Request	-	Special Use Permit for School
Location	-	3547 Quast Lane
Applicant	-	Kadee Anstadt, Superintendent Washington Local Schools 3505 W. Lincolnshire Blvd. Toledo, OH 43606
Owner	-	Washington Local Schools 3505 W. Lincolnshire Blvd. Toledo, OH 43606
Architect	-	Rusty Wilke The Collaborative One SeaGate, Park Level 118 Toledo, OH 43604

The staff recommends that the Toledo City Plan Commission recommend approval of SUP-11003-23, a Special Use Permit for a school at 3547 Quast Lane, to the Toledo City Council, for the following two (2) reasons:

SPECIAL USE PERMIT
TOLEDO CITY PLAN COMMISSION
REF: SUP-11003-23
DATE: March 14, 2024
TIME: 2:00 P.M.

SHEET TITLE
PROPOSED SITE
PLAN

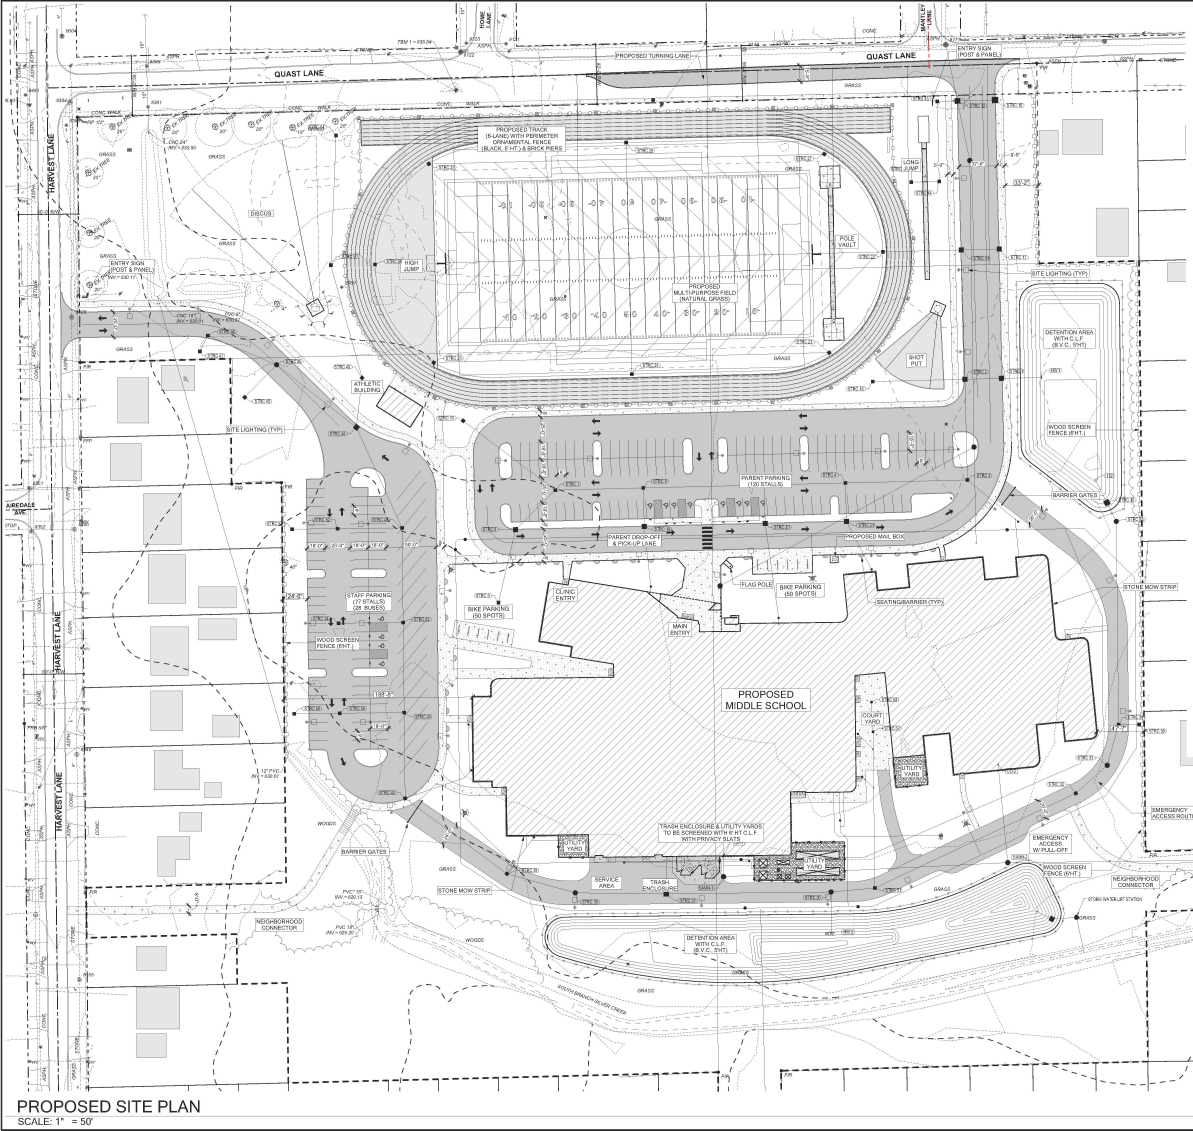
The layout of the school's parking plan is comprised of two lots: the north lot, which has access off of Quast Lane, and the west lot, which has access off of Harvest Lane. There will be one hundred and ninety-six (196) total spaces on site, in addition to sixteen bus spaces (16) in the west lot. Per TMC§1107.0304 – *Schedule "A"*, middle schools require one (1) space per faculty member, plus one (1) space per three (3) staff members, plus one (1) space per fifty (50) students for pickup and drop off. The school has an expected enrollment of 1,580 students, with one hundred sixty-five (165) faculty and twenty (20) staff, requiring two hundred and four (204) spaces. The proposed one hundred and ninety-six (196) spaces do not meet the minimum requirement per the middle school parking standards, however, the Planning Director has determined this number of parking spots is acceptable and will meet parking demands.

(TMC§1107.0300). A minimum of one (1) bicycle space shall be provided per three (3) students, plus one (1) space per ten (10) parking spaces for faculty and staff, but as per TMC§1107.0900, no more than 50 bicycle parking slots shall be required for any listed use category. The site plan depicts two areas for bicycle racks adjacent to each parking lot, both with capacity for fifty (50) bicycles, for a total of one hundred (100) bicycle parking slots. This number of slots is acceptable as depicted.

The entry drive off of Quast Lane depicts four (4) trees that are forty feet (40') apart and no continuous shrub hedge. However, there is a fence depicted between this entry drive and the abutting residential lots that will provide adequate screening. The entry drive off of Harvest Lane depicts five (5) trees that are sixty feet (60') apart and no continuous shrub hedge. The number of trees along this driveway are acceptable due to their anticipated size, however, revised plans shall show a continuous shrub hedge to provide adequate screening between this entry drive and the abutting residential lots.

32. All parcels within the proposed project site shall be combined.
33. Per TMC§1107.0600 – Off-Street Parking Schedule “A” Per Parking Schedule A, the minimum number of parking spaces required for a middle school is one (1) per faculty member, plus one (1) per three (3) staff members, plus one (1) space per fifty (50) students for student drop-off and pick-up. **Applicant is proposing 196 spaces – acceptable as depicted per the Planning Director.**

- a. A thirty-foot (30') frontage greenbelt is required along Harvest Lane and Quast Lane and shall include one (1) tree per every thirty feet (30') of frontage; **not acceptable as depicted; applicant shall obtain a waiver of TMC§1108.0202.**

street, place, or driveway and shall be provided abutting the parking area to visually screen all off-street loading facilities from view of public rights-of-way. A minimum of at least one canopy tree must be provided for each thirty (30) linear feet, plus a continuous shrub with a minimum height of eighteen inches (18"); **not acceptable as depicted on site plan; applicant shall obtain a waiver of a portion of TMC§1108.0204 requirements and perimeter shrubs shall be provided along the entry drive off of Harvest Lane to adequately screen abutting residential lots;**

Approve waiver for the frontage greenbelt requirement. The site plan depicts a twenty-five-foot (25') frontage greenbelt along a portion of Quast Lane and is acceptable as depicted. Most of the frontage greenbelt meets the thirty-foot (30') requirement.

Approve waiver for the perimeter landscape requirement along western side of the west parking lot, where three (3) trees are missing. The proposed fencing will provide adequate screening between abutting residential lots.

Approve waiver for perimeter landscaping along entry drive off of Quast Lane and entry drive off of Harvest Lane. The trees along both drives are further than thirty feet (30') apart there are no proposed shrubs in the landscape plan. The depicted trees are adequate due to expected size. The missing shrubs along the Quast entry drive are acceptable, as there is a proposed fence that will provide adequate screening between abutting residential lots. The applicant will provide the shrubs missing along the Harvest Lane entry drive, as there is no proposed fence along this drive.

OVERALL
LANDSCAPE
PLAN

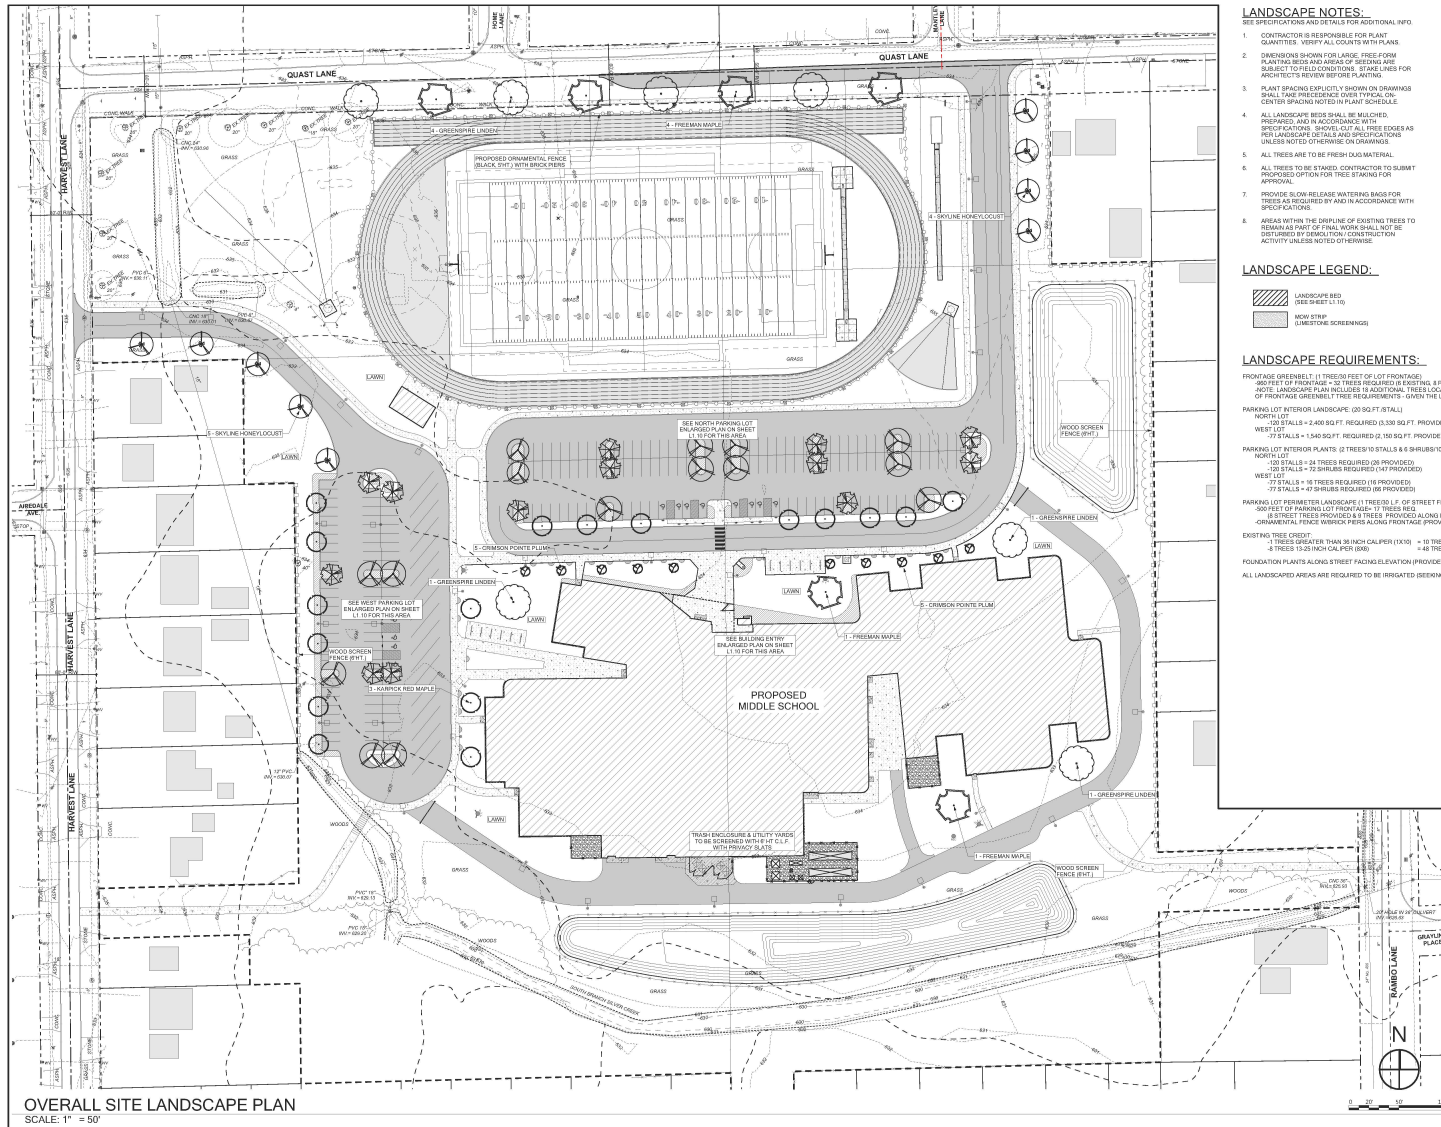
Per TMC§1108.0202 – *Frontage Greenbelts*, sites over five (5) acres are required to provide a thirty-foot (30') frontage greenbelt and contain at least one (1) tree for every thirty feet (30') of frontage. This standard applies to the 245 feet of frontage along Harvest Lane on the northwest corner of the site, as well as the 960 feet of frontage along Quast Lane. The two frontages total to 1,205 feet and require forty-two (42) trees. The submitted site plan depicts eight (8) new trees and nine (9) existing trees, which are credited per TMC§1108.0407(1)(B) and count as fifty-six (56) trees due to their caliper. The frontage greenbelt meets requirements in terms of number of trees, however, a portion of the greenbelt along Quast Lane is only twenty-five feet (25') wide. The applicant shall obtain a waiver for this section of the frontage greenbelt.

Parking lot landscaping is essential in preventing headlights from being seen from public rights-of-way, curbing the urban heat island effect, and in beautifying the site. TMC§1108.0204 – *Parking Lot Landscaping (Interior and Perimeter)* states a perimeter landscape buffer shall be provided abutting the parking area to visually screen all off-street loading facilities from view of Residential districts and public right-of-ways. A minimum of at least one (1) canopy tree must be provided for each thirty (30) linear feet, plus a continuous shrub with a minimum height of eighteen inches (18"). The site plan depicts six (6) trees and a continuous shrub hedge along the western side of the west parking, which is two hundred and seventy (270) feet long. This length of parking lot is missing three (3) trees, however, a six-foot (6') wooden screen fence is also depicted along the lot, which provides adequate screening between the abutting residential lots.

Pursuant to TMC§1108.0204(B), the total interior landscaping required for parking lots is twenty (20) square feet per parking space. The site's parking lots contain a total of one hundred and ninety-six (196) parking spaces, which requires a minimum of 3,920 square feet for interior

landscaping provided within the parking lots. Additionally, two (2) canopy trees and six (6) shrubs are required to be installed in interior landscape areas for each ten (10) parking spaces within the parking lot. One (1) canopy tree may substitute for three (3) shrubs. A total of forty (40) trees and one hundred and nineteen (119) shrubs are required in the interior parking. The site plan shows 5,480 square feet of interior parking lot landscaping, comprised of forty-two (42) trees and two hundred and thirteen (213) shrubs. These plantings meet this requirement.

- g. If the site is ½ acre or larger, landscaped areas must be irrigated as necessary to maintain required plant materials in good and healthy condition. Irrigation plans must be submitted with development plans and must contain all construction details; **not acceptable as depicted; applicant shall obtain a waiver of TMC§1108.0406.**

Approve a waiver to not require irrigation for the site. The funding source for construction of the new school does not cover costs for an irrigation system. Additionally, the project is seeking to be LEED certified, and irrigation is not permitted in order to obtain certification. The landscaping schedule shows native plantings with high tolerance to drought.

ELEVATIONS

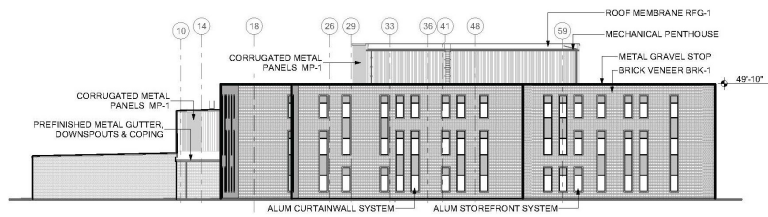
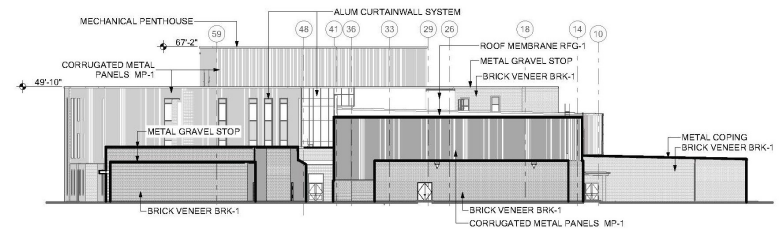
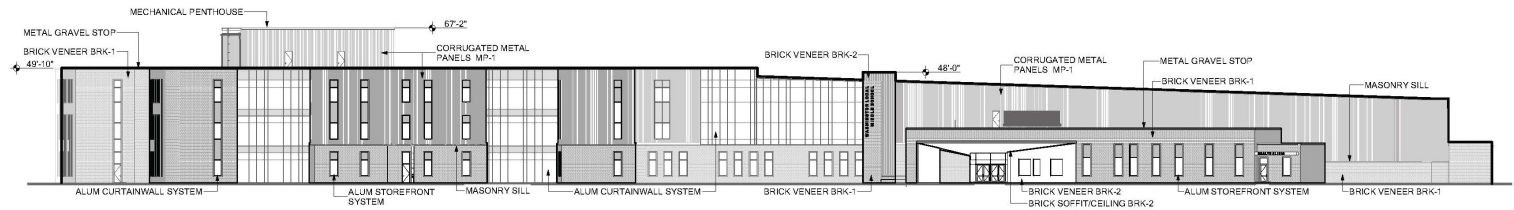
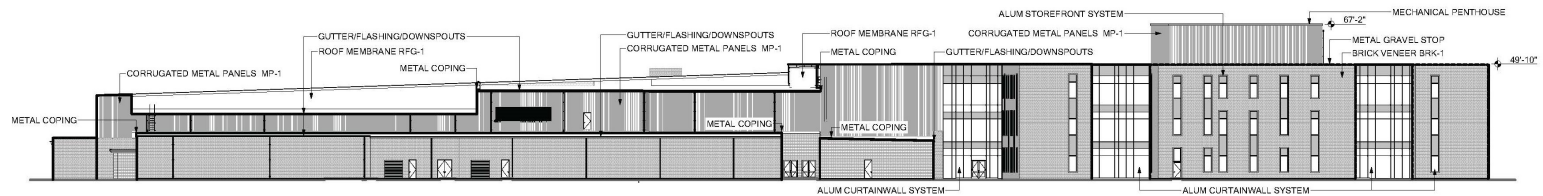
Furthermore, the submitted building elevations depict a combination of brick masonry (48%), architectural metal (33%), and glass and glazing (19%). These are the same materials that were previously approved and installed at Shoreland Elementary and Silver Creek Elementary. As all of these materials are listed as approved predominant materials in TMC§1109.0500 – *Building Façade Materials and Colors*, the elevation plans are acceptable as depicted.

The maximum building height in the RS6-Single Family Residential zoning district for schools, per TMC§1106.0206, is sixty (60) feet. Elevations submitted to the Plan Commission indicate the height of the tallest portion of the building is sixty-seven (67) feet and two (2) inches. Staff is supportive of a waiver to allow this height, as the building is setback an appropriate distance from the abutting residential parcels.

- i. The location and direction of any proposed lighting (**any lighting is to be directed away from adjacent residential properties**).
40. Building elevations shall be of quality materials as stated in TMC§1109.0500. Architectural metal shall have a minimum 22 gage face sheet. **Acceptable as depicted (brick masonry (48%), architectural metal (33%), and glass and glazing (19%)).**

Approve waiver for additional seven feet and two inches (7'2") over the maximum height requirement as the proposed school is set back far enough from the abutting residential parcels.
